UNITED STATES PATENT AND TRADEMARK OFFICE

APPLICATION NO.	FILING DATE	FIRST NAMED INVENTOR	ATTORNEY DOCKET NO.	CONFIRMATION NO.
10/659,933	09/11/2003	Takuya Ishida	81863.0021	5059
26021	7590	11/30/2005		
HOGAN & HARTSON L.L.P. 500 S. GRAND AVENUE SUITE 1900 LOS ANGELES, CA 90071-2611			EXAMINER ADDISU, SARA	
			ART UNIT	PAPER NUMBER
			3722

Office Action Summary	Application No. 10/659,933	Applicant(s) ISHIDA, TAKUYA	
	Examiner Sara Addisu	Art Unit 3722

DETAILED ACTION

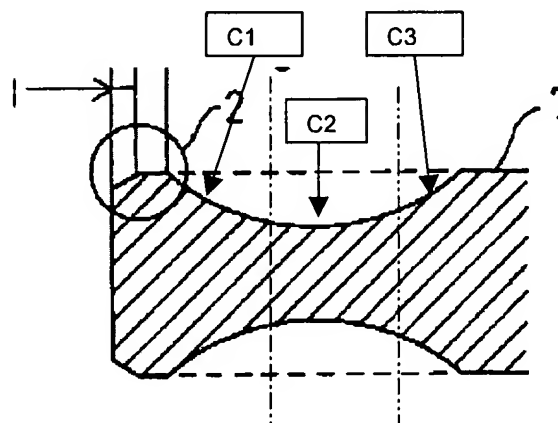
Toyose teaches a double-sided insert having a planar seat (7) and land (4) with a straight part (9) that is on the same plane (i.e. same height) as the seat (7) (JP 11-277307, figures 2 and abstract). Both the straight part (9) of the land and seat (7) serve as contact surface when attached to the tool holder (JP 11-277307, figure 3). Toyose also teaches a recess (5) having a first curve (c1), second curve (c2) and third curve (c3) (see figure below).

Therefore, it would have been obvious to one of ordinary skill in the art at the time of the invention was made to modify Niebauer's invention such that land has a portion that is flat and at the same height as the top surface of plateau (with protrusion),

as taught by Toyose for the purpose of having the added support to significantly reduce chatter and thus improve the surface finish of the workpiece being machined. It would have also been obvious to one of ordinary skill in the art at the time of the invention was made to modify Niebauer's invention such that the recess has curves as taught by Toyose for the purpose of assisting the flow of chips from the workpiece.
